re: **Response to City Comments**
 Proposed Residential Development
 475 Terry Fox Drive – Ottawa, Ontario

file: PG7418-MEMO.01 Revision 4

City Review Comments (August 29, 2025)

SLIDEINTERPRET 9.031	Project Ironclad Developments Inc. Slope Stability Analysis 475 Terry Fox Drive, Ottawa, Ontario		
	Figure No. Figure 1A - Section A - Proposed Conditions - Static Loading		
	Drawn by: NFRV	Company: Paterson Group	
	Date: 2026-01-05	File No. PG7418

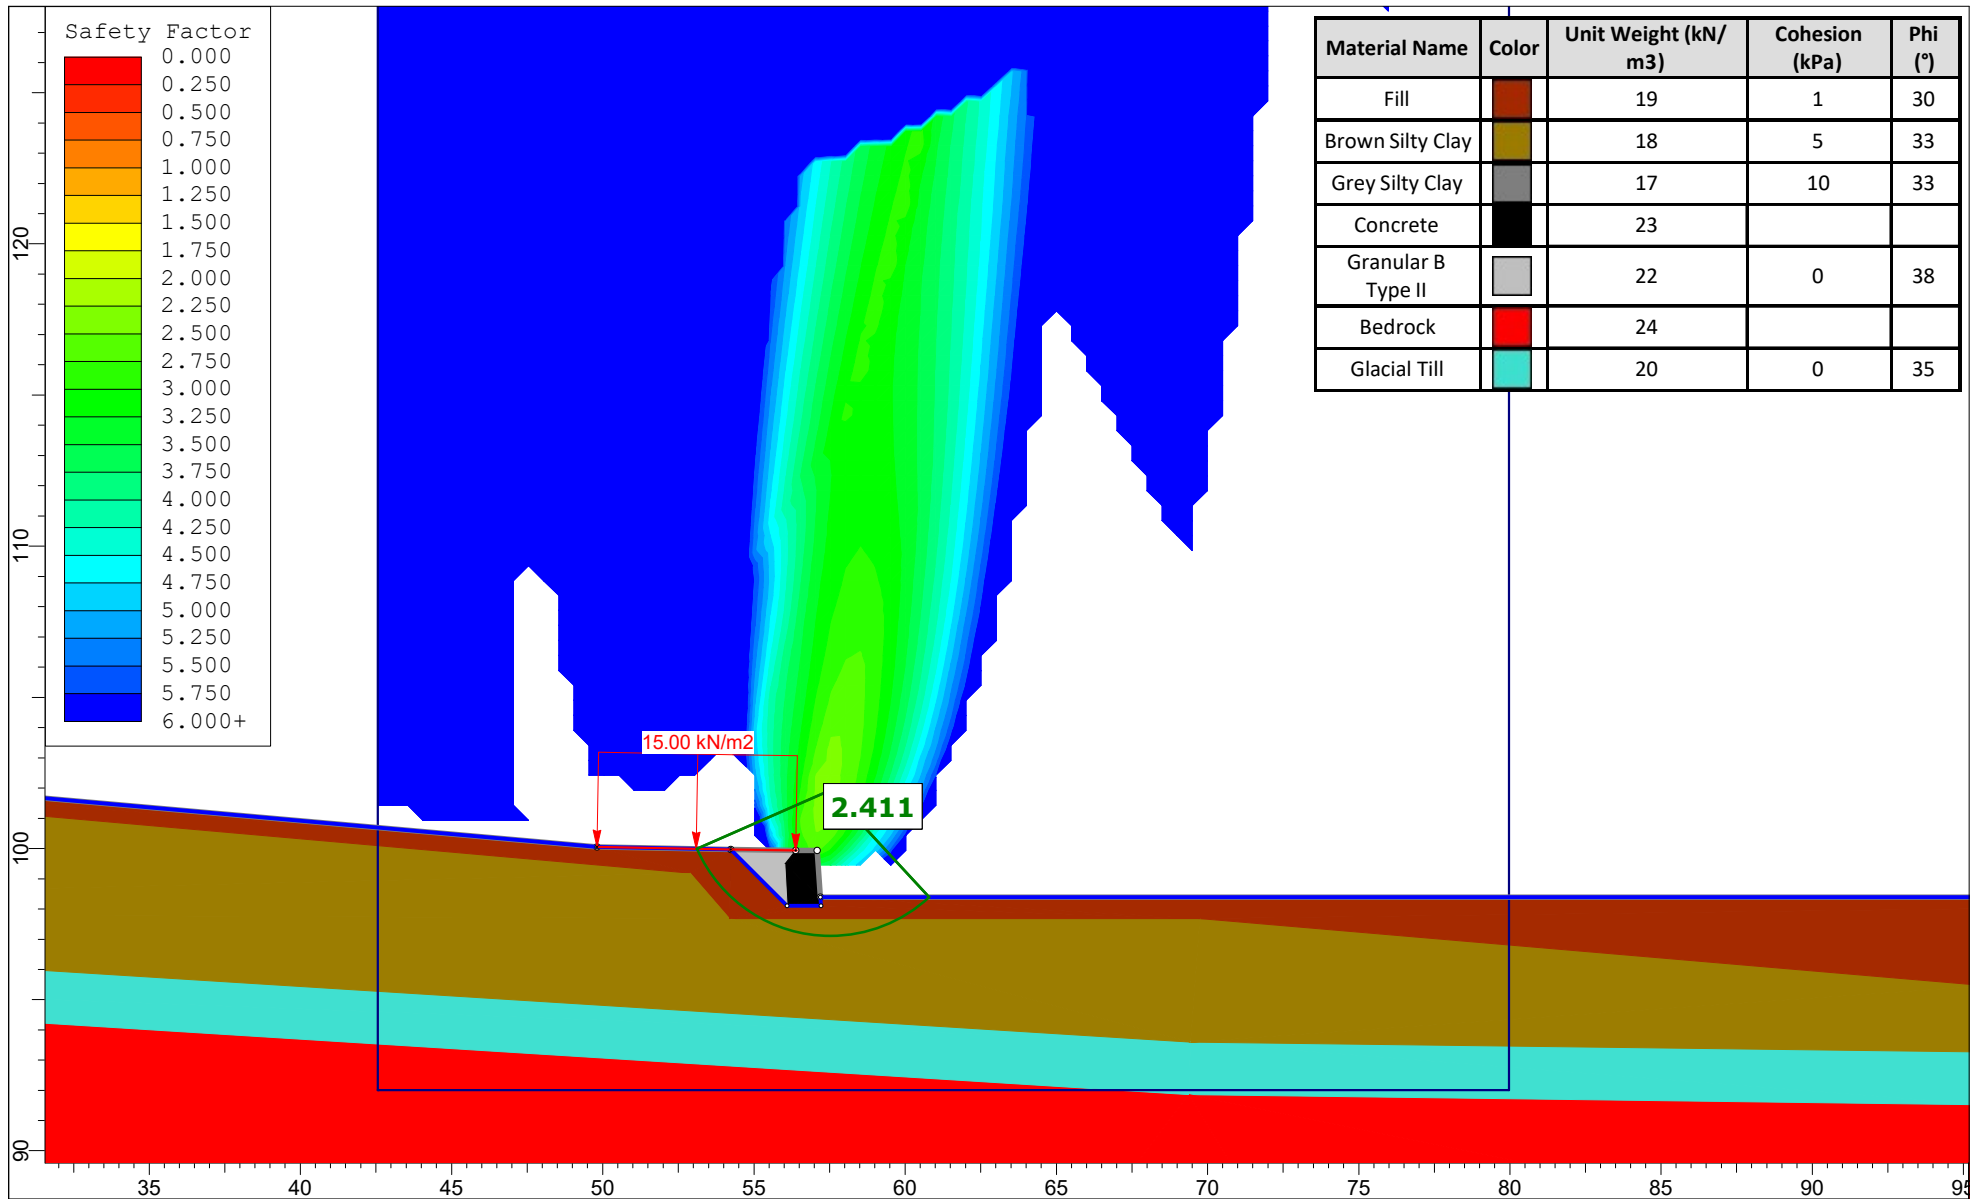
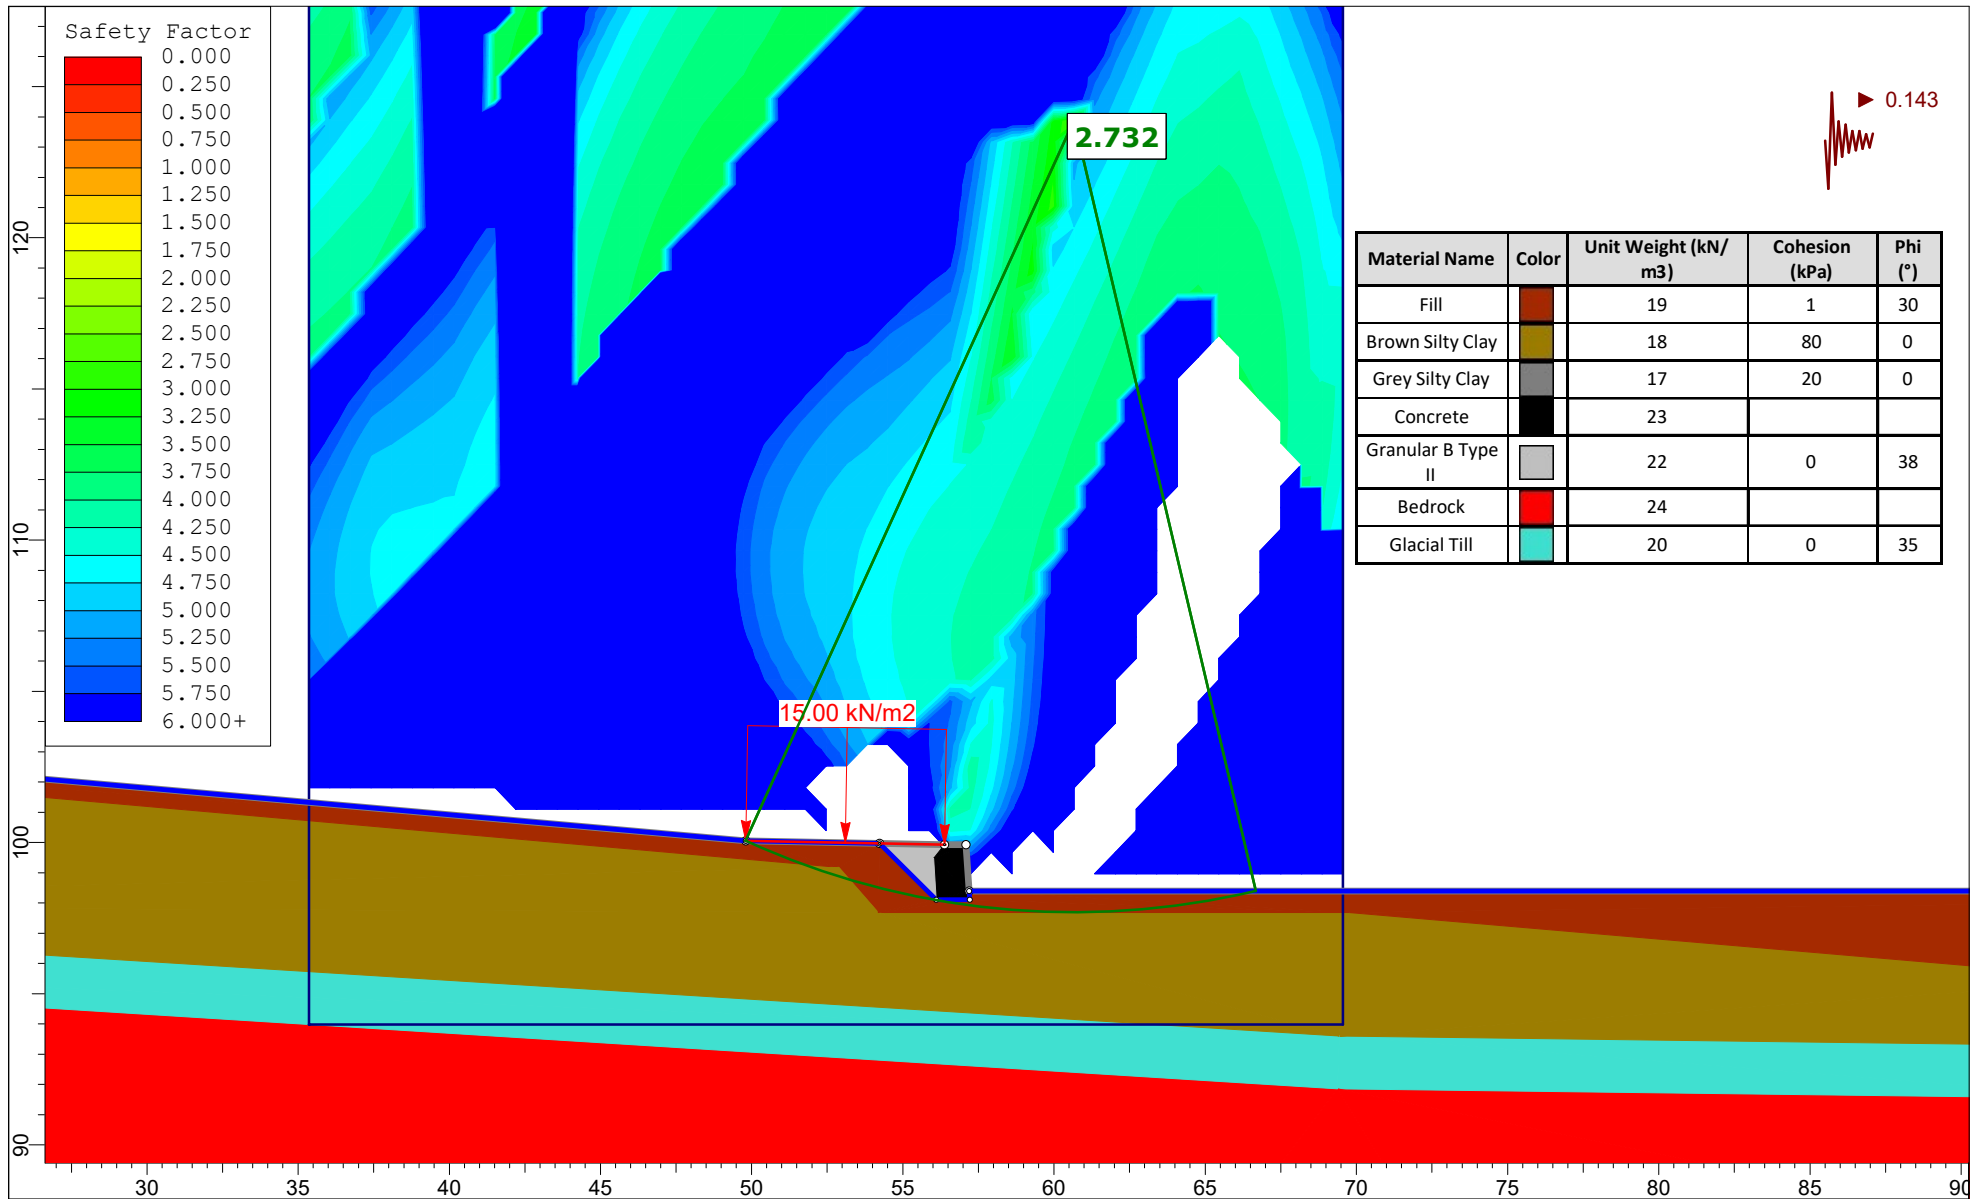
Comment 6: *Please coordinate with the civil consultant to confirm if the proposed retaining walls on site will require a global stability analysis report and drawings. These documents will be required to make for a complete submission if the proposed retaining walls are greater than 1.0 m in height.*

Comment 73: *Thank you for providing a global stability analysis for the highest section of the retaining wall. Although this is the highest section of the retaining wall, can you confirm that it is also the most critical cross-section that could be analyzed for this site? Perhaps the highest section of the retaining wall may not be the most critical if elsewhere along the wall larger trees are being proposed closer to the top of wall? Please confirm.*

Response: Based on Paterson's review of the currently proposed grading concepts, retaining walls reaching up to 1.54 m in height will be required. Based on this information, Paterson has subsequently prepared a global stability analysis of the highest and most critical segment of the proposed retaining wall structure based on the current civil design drawings. This analysis considers a surcharge of 15 kPa, equivalent to typical traffic loading, representing trees to consider their presence along the top of the wall area.

Based on our review, the factors of safety for the static and seismic loading cases exceed the required minimum factors of safety of 1.5 and 1.1, respectively, and are considered acceptable from a geotechnical and global stability perspective. The analysis was undertaken using SLIDE, a computer program which permits a two-dimensional slope stability analysis using several methods including the Bishop's method, which is a widely used and accepted analysis method. The cross-sections are appended to this memorandum.

Response: Reference should be made to our response to Comment #7. In summary, Paterson has confirmed that the section considered is the most critical section and an additional surcharge has been applied to consider the presence of trees equivalent to typical traffic loading.

FIGURE 4

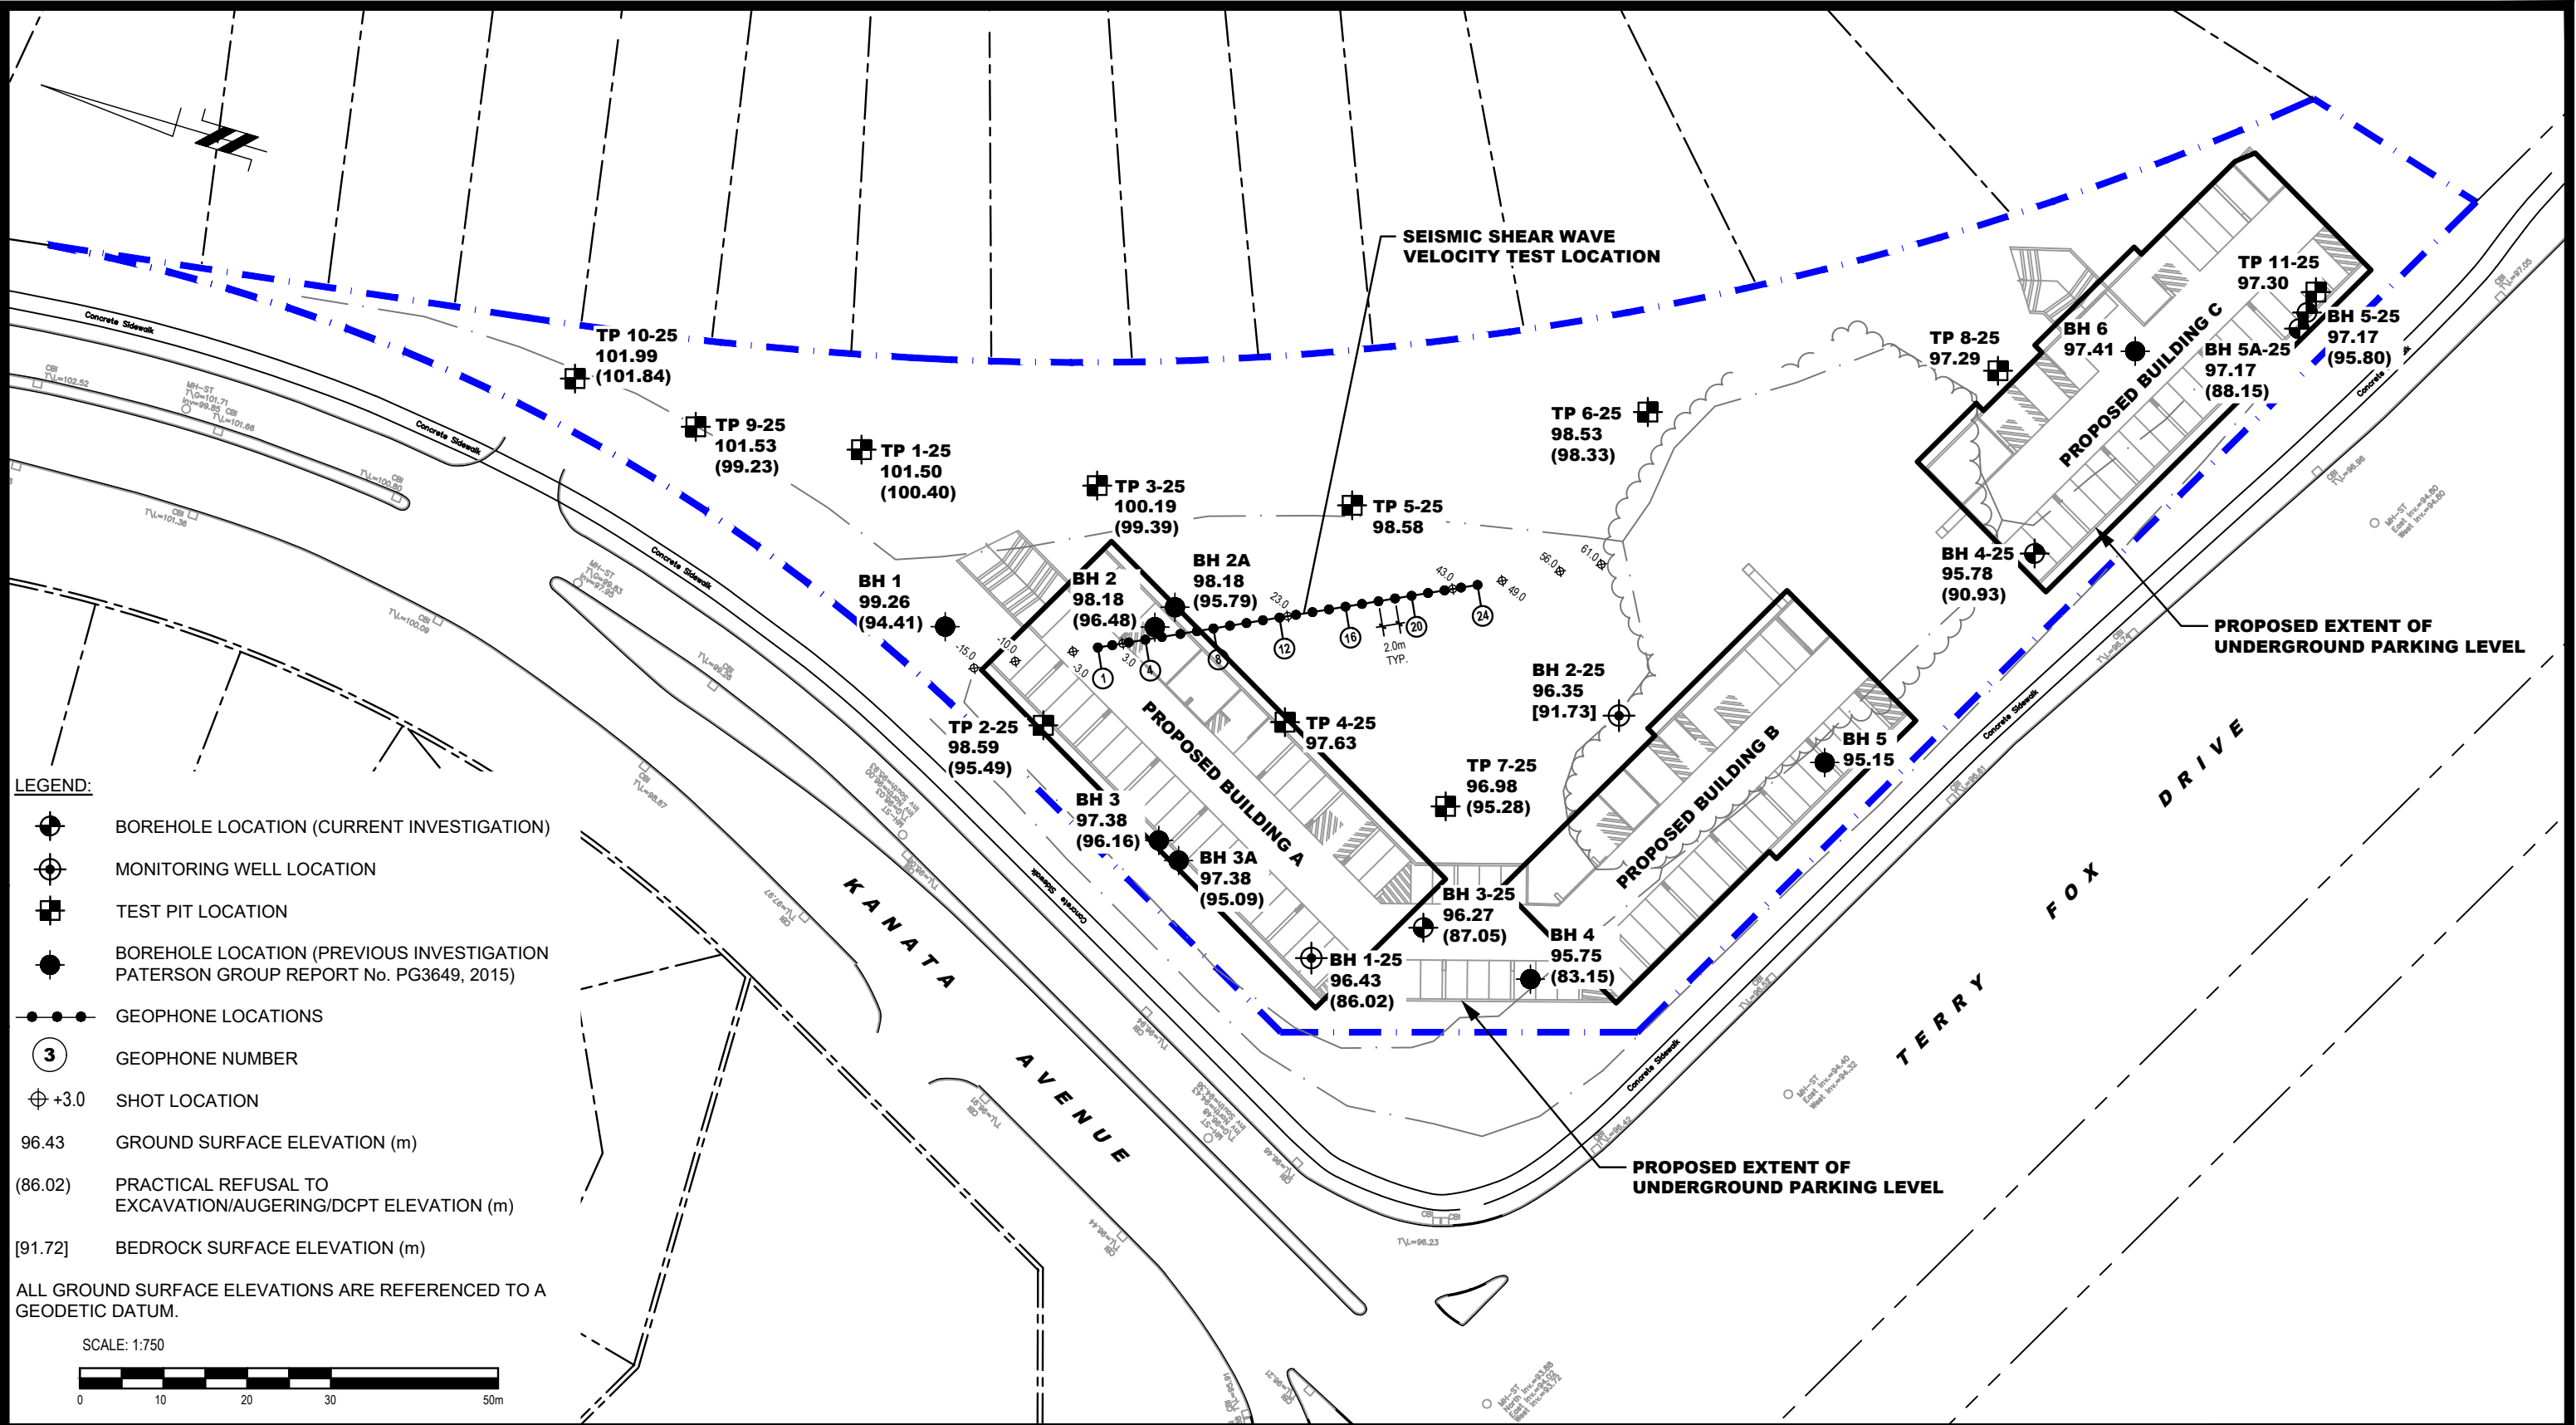
Comment 7: *Cross-sections are required for the proposed retaining walls.*

Comment 74: *[City's response to previous deficiency #7]: Noted, this comment has been moved under the comments section. Please provide the actual cross-sections of the proposed retaining wall once available.*

Response: Cross-sections of a typical segmental block retaining wall design that will be required for the proposed retaining wall during the detailed design stage has been appended to this memorandum in response to this comment. The attached typical detail provides an example of the type of retaining wall structure that is considered feasible and suitable for the subject site from a geotechnical perspective.

Response: This comment has been acknowledged; this will be provided at the detailed design stage when the retaining wall design is typically and most appropriately complete.
